APPEAL OF PLANNING COMMISSION DECISION

6497 South Kennedy

Subject: Formal Appeal of Approval for Development at 16497 S. Kennedy Road

Photos from a very limited vantage from proposed property

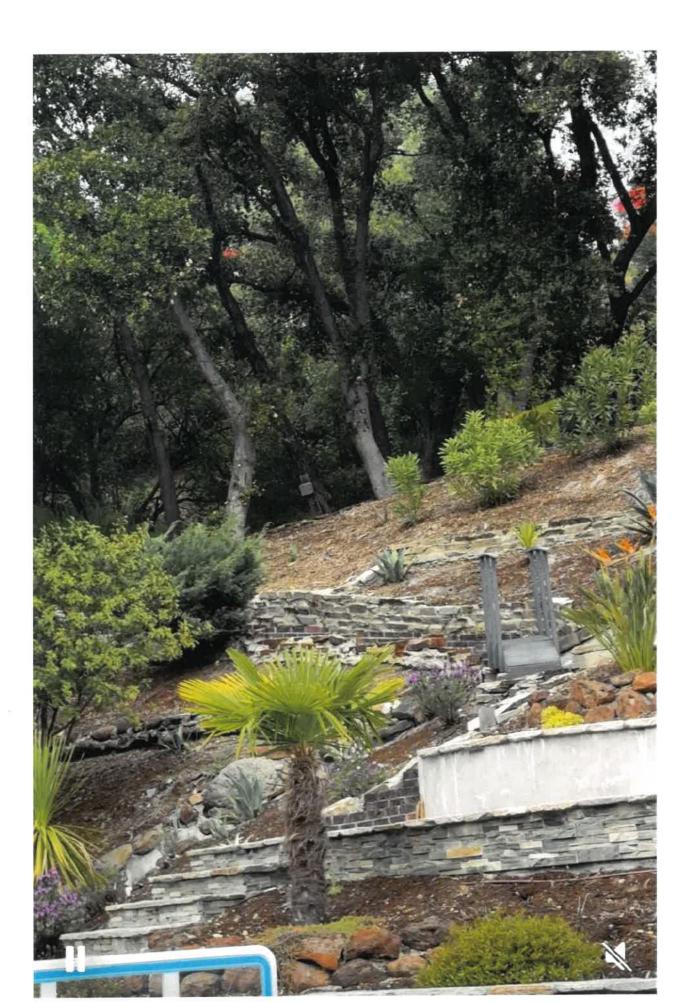
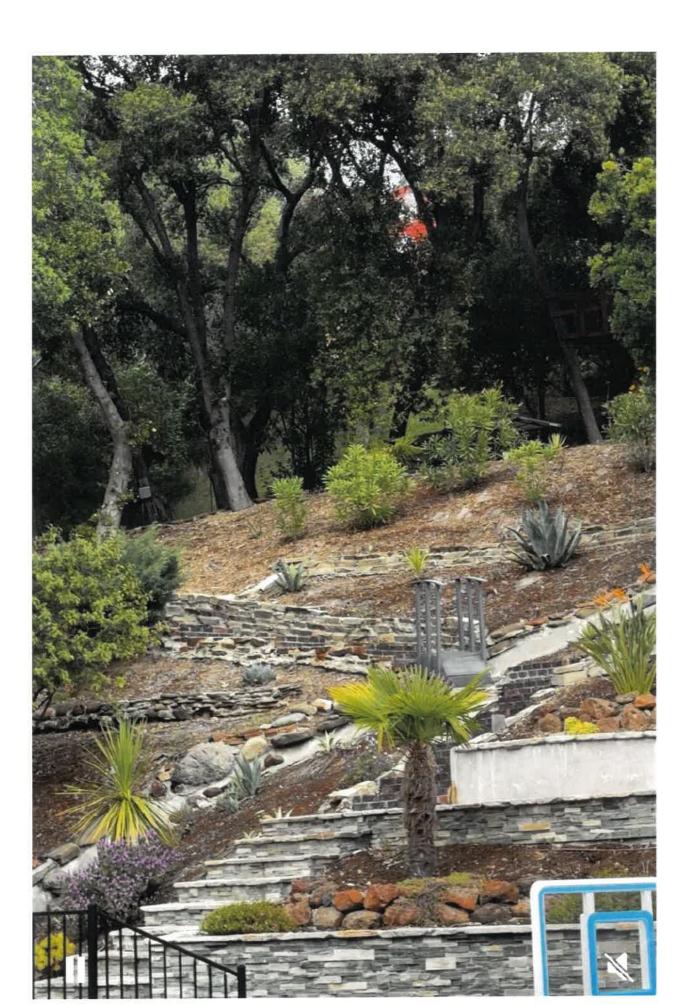
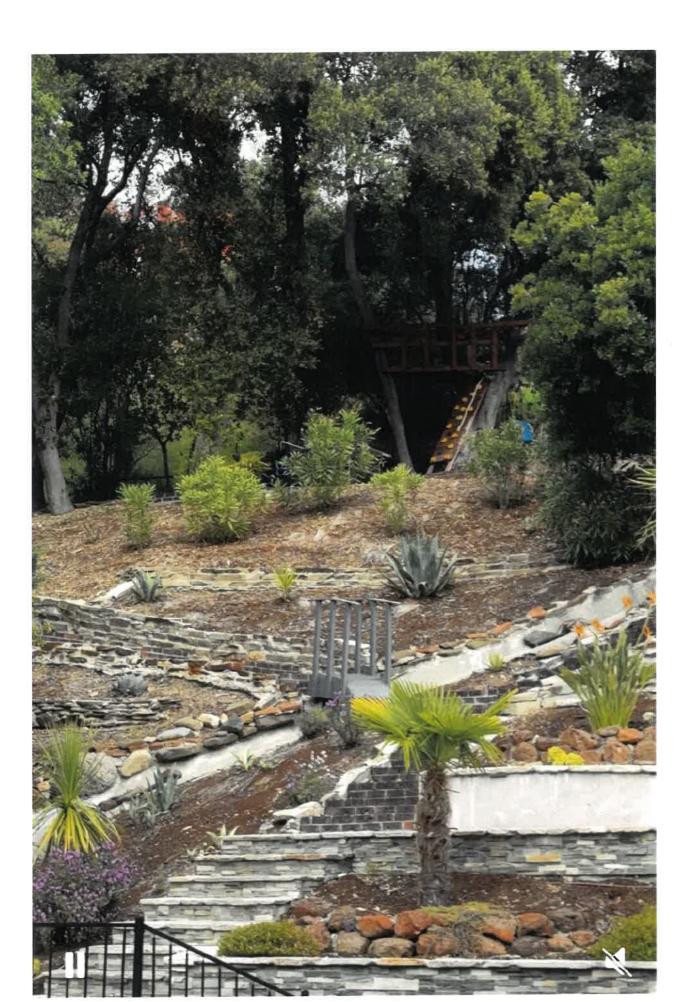
- B. Inadequate Assessment Methodology and Presentation: Mr. Nicol presented photographic documentation taken from ground level and locations far removed from the actual elevation and positioning of proposed windows and decks. He further acknowledged during a walkthrough on his land, that his photographs were taken without considering realistic sightlines from the proposed structures. With Mr. Nicol's permission, I visited the development site and was able to see my swimming pool and bedroom windows from multiple ground-level points. The visual materials presented to the Town were, therefore, incomplete and misleading, and do not represent the actual privacy intrusions posed by the development. Below are some photos I took from the site and without having the right vantage I could already see how our privacy at the pool will be violated.

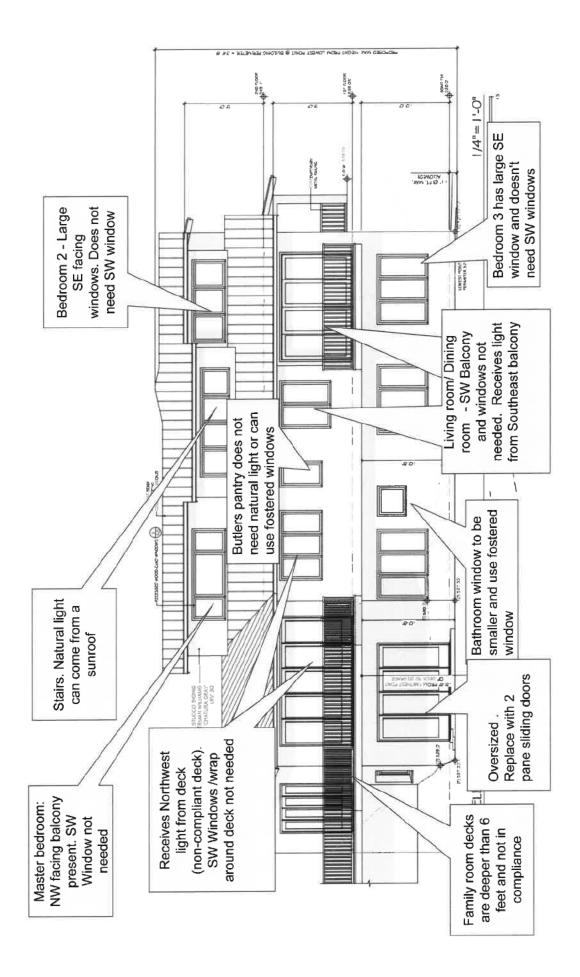
C. Southwest-Facing Openings, Decks and Erroneous Light Assumptions: During the townhall / meeting, one of the council members raised a legitimate concern about the numerous windows and doors facing the southwest elevation (our home), only for another member to dismiss it, stating this is the only side where the home receives natural light. That reasoning is factually incorrect.

Many of the rooms facing our property already have alternate sources of light from other elevations, or are rooms where natural light should not take precedence over privacy (eg. Butler's Pantry, Stairs et al). Below is a breakdown of room-by-room analysis:

In summary most of the southwest facing windows can be reduced without compromising natural light.

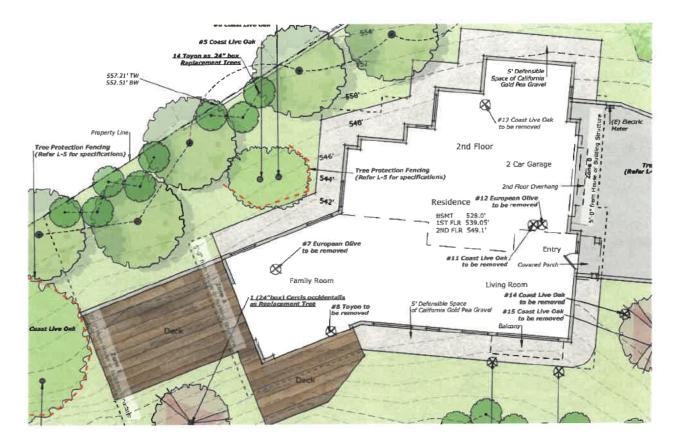
- a) From the architectural elevation (previous image), the plans clearly label the railings on both decks and balconies as "Contemporary Metal Railing." These railings appear to be open, vertical baluster-style, and not designed to provide any privacy screening.

- b) Both Decks off the Family Room are significantly larger than <u>six feet</u> in depth. The wrap-around design and dual extension structure likely exceed 10–12 feet in depth in certain parts.

- c) The balconies on the first floor (from the elevation view) also appear to extend more than six feet out from the building in some areas.

In summary I believe the council has erroneously approved all the decks which are contrary to its own guidelines.
